CAMPUS AREA NEIGHBORHOOD ASSOCIATION

Lake Street Garage Steering Committee Report

November 21st, 2022

Alternate Layout

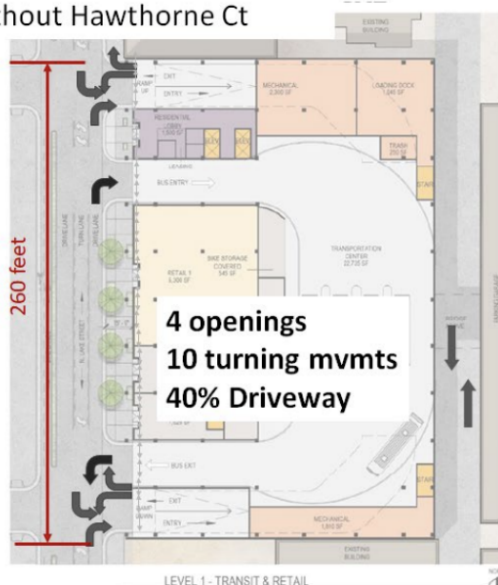
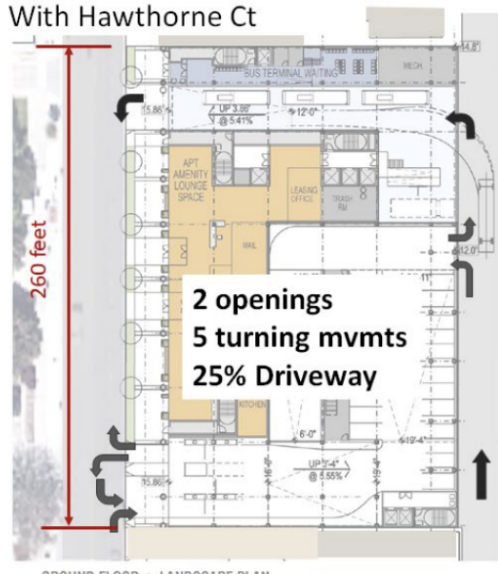
The traffic flow of the current proposal requires intercity buses to cross important, busy lanes of traffic that include **the Major BRT (Bus Rapid Transit) Lane, the unprotected Bike Lane, and the Major Sidewalk**. This is a major logistical flaw as this presents lots of opportunities for major backups on University Ave due to buses not being able to cross the lanes of traffic and a higher risk of accidents due to the Hawthorne Ct functioning as an alleyway and not being a controlled intersection. Not to mention University Ave is a much faster street than Lake Street and increases the risk of accidents like fender benders and bikers being hit during rush hour traffic. The development needs to use Lake Street for buses because it is a controlled intersection with a stoplight as compared to the Hawthorne Ct entrance which has no traffic signals. Additionally, the East Campus Mall BRT Spot can be inferred as a major bus stop for students commuting across campus. The three major residence halls are within a couple of blocks of this spot. Blockages at the Hawthorne Ct entrance will disrupt this major BRT system hub.

The three spots for buses seem inadequate and are shortchanging the intercity bus station potential. The bus terminal ought to have five bays like the old bus terminal and there needs to be a better plan for staging. They are trying to do too much at once and seem to be modeled after La Crosse without consideration of the unique challenges of this area. The Bus terminal is different and you can drive straight through it. This design

seems too complex at the moment. The proposal does not seem to completely address everything. The entrances for residential parking are on the same side as the Van Galder Bus entrance. This mix of traffic seems problematic with bus schedules and the residential experience. If there is a queue that wraps around the corner, this will affect the BRT lane and Metro Bus lane. There is also a need for more entrances and exits to accommodate queues during special events.

- Moving the entrances to the bus terminal and parking to Lake Street
- Creating a Transportation plan that considers all modes of transportation on the site
- Using this project to activate Hawthorne Court with public art, lighting, and cameras
- Make the bus terminal part of a covered part of Lake Street.
- We need a complete Traffic/Environmental Study that considers the impact on local businesses, existing apartments, and all current modes of traffic circulating through this site.
